Auckland Surf Park Community

Stage 1 - s.127 Amended Resource Consent Conditions

Condition amendments dated February 2026 are shown in red underline and ~~striketrough~~

Figure 1: PV 5 Sub-Array Arrangement

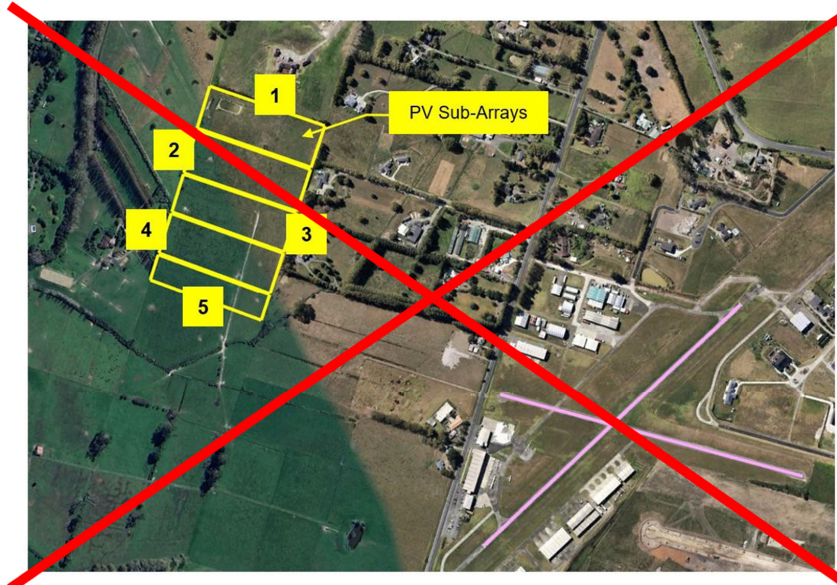
Commented [EK1]: Deletions:
 Solar Farm layout differs significantly from Stage 2 therefore all references and Conditions relating to the Solar Farm are to be deleted from this Stage 1 approval and applied instead to Stage 2
